Public Comment to
 UNFC Petroleum Resources Specifications and Guidelines (PRSG)
 Imre Szilágyi

The Expert Group on Resources Management of the UN Economic Commission for Europe (UNECE) has elaborated and presented the draft of Petroleum Resources Specifications and Guidelines (PRSG) to the global resources management system of the United Nations Framework Classification for Resources (UNFC).

Fig. 2. Project resources in UNFC

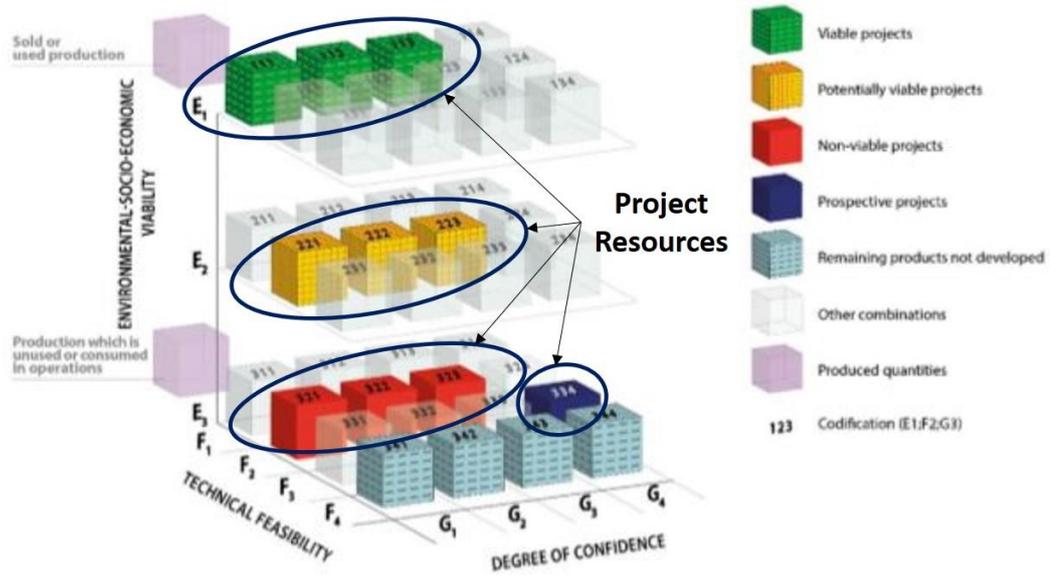
3. If G2 and G3 quantities (in any reasonable F and E combinations) are mathematical differences of two viable scenarios we may conclude that volumes in the G2 and G3 classes are not assignable to recovery projects. I think it conflicts the statement that "*UNFC is a project based classification and management system*" which may suggest for the users that volumes in any E-F-G combination – for instance 2.2.1. - are standalone recovery project resources. As of this, they cannot be differences of two project scenarios (e.g. 1.1.2. & 1.1.3. or 2.2.2. & 2.2.3. or 3.2.2. & 3.2.3., see Fig. 1).

In fact, volumes of 1.1.1., 1.1.2., 1.1.3.; and 2.2.1., 2.2.1., 2.2.2., 2.2.3.; and 3.2.1., 3.2.2., 3.2.3. are together assigned to separate (viable, potentially viable and non-viable, respectively) recovery projects for discovered resources, plus 3.3.4. for undiscovered (as demonstrated in Fig. 2).

Fig. 3. Deterministic project recovery scenarios

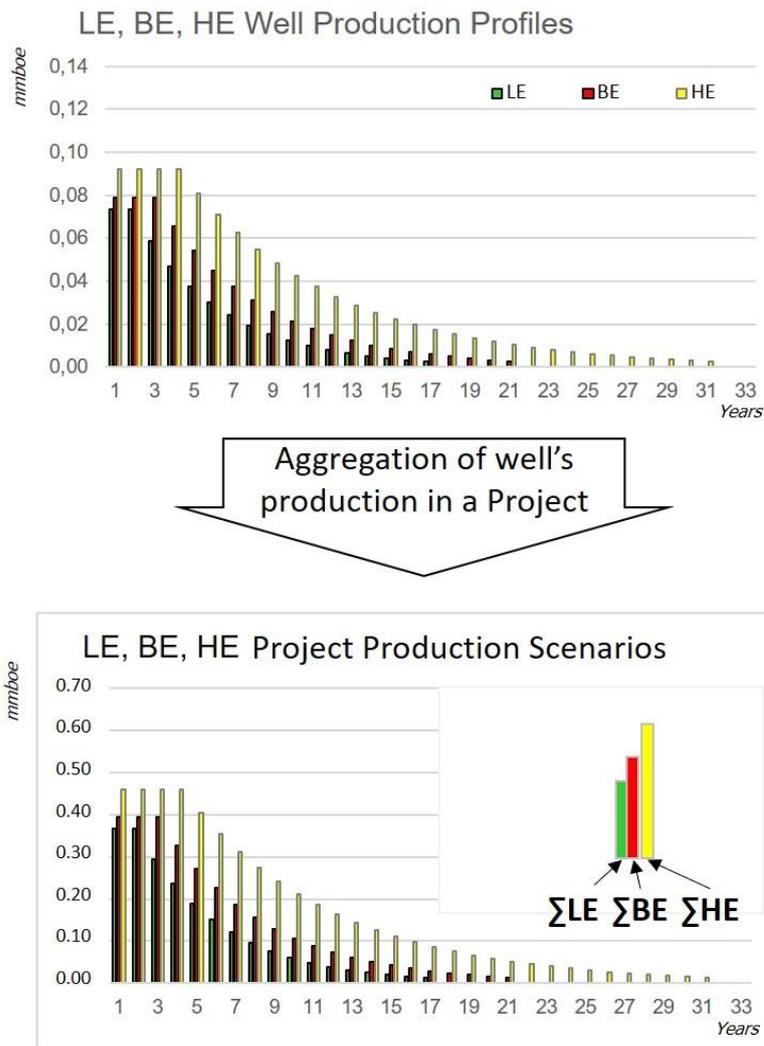
Furthermore, I note here that the application of the probabilistic resource assessment method (*Chapter 6.4.2. of PRSG*) to a (potential) *project* recovery is challengeable. (For the Volume Initially In-Place and for the Estimated Ultimate Recovery of a *deposit* it is not.) Project recovery scenarios (Low, Best, High Estimates) by definition are cumulative production forecasts of wells assigned to the project (Fig. 3), and as such, they are deterministic. True however, that each deterministic scenario-based estimate can be considered as a reasonable realization of sampled values of the resource estimation parameters with stochastic outcome distributions.

Fig. 4. Re-interpretation of the Degree of Confidence

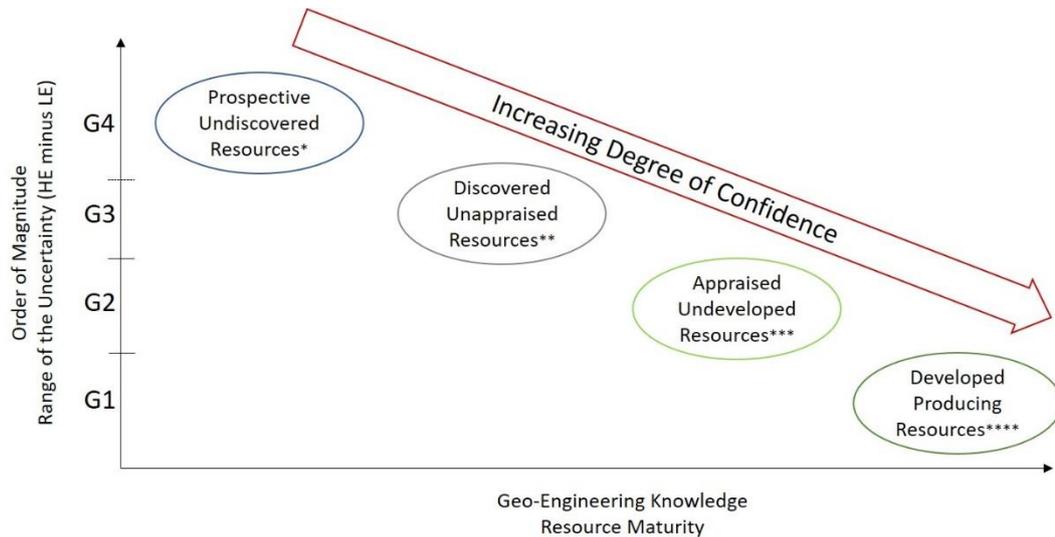
- A. Alignment of the Degree of Confidence criterion with the Range of the Uncertainty in recovery project volume’s estimations: let it assume that the less uncertainty is perceived (the narrower the range is) the more confident one can be about having the resource in hand. Well-known that the order of magnitude in the range of the uncertainty gradually decreases with the resource (non-commercial) maturation, i.e. the order of magnitude of the range is the highest at Prospective (undiscovered) Resources in the exploration phase, while (normally) it is less after the discovery and prior to the appraisal, even less after the appraisal and before development, finally it is the lowest for the production forecast of the developed volumes. The assumption lays on the fact that the consecutive maturation projects

(exploration > appraisal > field development > production) are gradually increasing the geo-engineering knowledge which enables to perform “more precise” estimations to the parameters controlling the estimations. Conclusively, G4, G3, G2 and G1 UNFC-volumes may correspond the Best Estimates of prospective (undiscovered) resources, the discovered unappraised resources, the undeveloped resources, and the resources of the producing projects (see Fig. 4).

- Version A: The Degree of Confidence could be aligned with the Resource Maturity (Fig. 4.). Under this scheme the Best Estimate volumes of exploration, appraisal, field development and production projects are assigned to G4, G3, G2 and G1 classes, respectively. At the same time aspects of resource maturity are removed from the criterion of Technical Feasibility. The modification will deliver the result that each “cube” of any reasonable G-F-E combination represents a viably assessable recovery project volume.

Fig. 5. The economic limit on cumulative undiscounted and discounted cash-flow curves

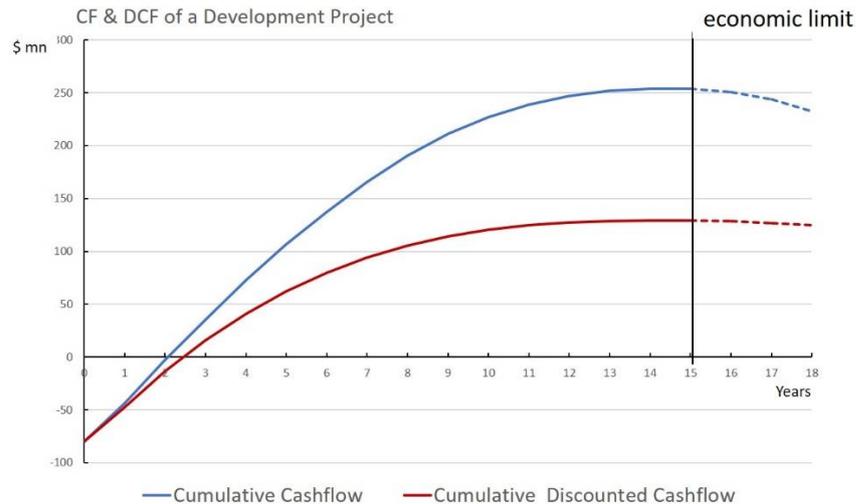
- At the discussion of the Economic Limit (*Chapter 4.4.*) PRSG suggests that “...*future production may be tested at an undiscounted rate...*” to determine the economic limit of a project. It is ambiguous whether PRGS wants to refer to undiscounted cash-flows or undiscounted production. If the former, the specification is redundant because the economic limit – i.e. when revenue no longer exceeds operating costs – is reached at the same time at the cumulative of the discounted and undiscounted cash-flows (see Fig. 5).

If the word “undiscounted” relates to production rates further explanation should be provided on its meaning (how to discount production rates?)

Fig. 6 Proposed assignments of Pg, Pd and Pc to UNFC classification criteria

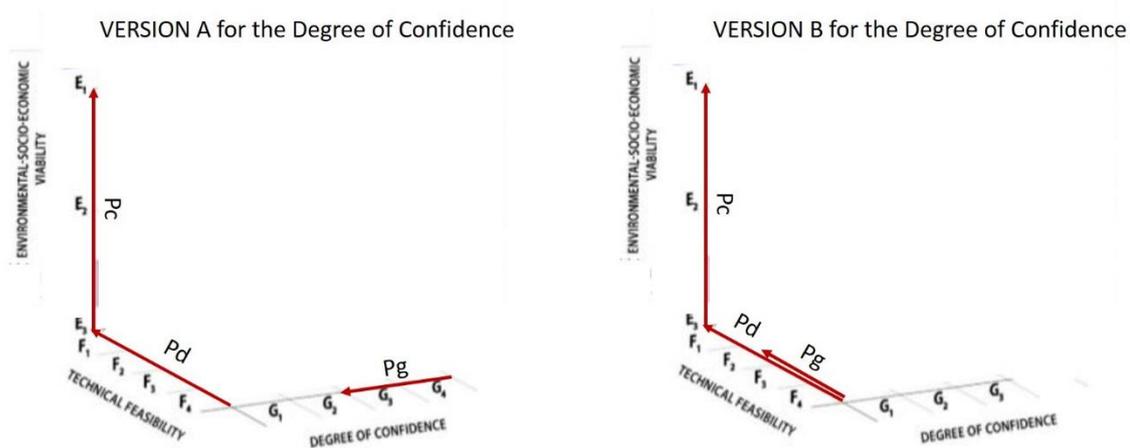
PRSG defines P_c as the multiplication product of P_g and the development probability, P_d . Chapter 5.2. discussing the consideration of risks is unambiguous about the understanding of P_d . The last sentence of the first paragraph, “the P_d includes the demonstration of a viable recovery technology” suggests that P_d is the chance for the implementation of a viable technology. The third phrase of the second paragraph however mentions the social-environmental-economic factors that are also needed to be evaluated at the assessment of P_d . I believe that risks of the technological viability and social-environmental-economic risks are different by nature and therefore should be separately assessed.

My suggestion is to assign P_c (probability of commercial success) to the Environmental-Social-Economic criteria (E-Axis) because these are in fact the criteria of commerciality. P_d (probability of the development’s technical success) should belong in this scheme to the Technical Feasibility (F) axis, while P_g (probability of geological success) is to be assigned to the Degree of Confidence criterion (G-Axis) if G-Axis classification follows the Version A approach to the Degree of Confidence discussed above. In case Version B is implemented at the G-Axis P_g should be assigned to the F-Axis – simultaneously with but independently of P_d (Fig. 6). Taken that P_g , P_d and P_c are probabilities for independent events the overall probability of recovery project success (let P_r to be introduced) shall be the multiplication product of P_g , P_d and P_g .

Regarding risk (actually success probability) evaluation I suggest the refinement of Pg (geological probability) by its extension to appraisal project volumes, the limitation of Pd

(development probability) to the technological success, and the assignment of P_c (commercial probability) to the environmental, societal and economic factors. The introduction of the overall probability of recovery project success (P_p) is recommended as the multiplication product of the reinterpreted P_g , P_d and P_c .
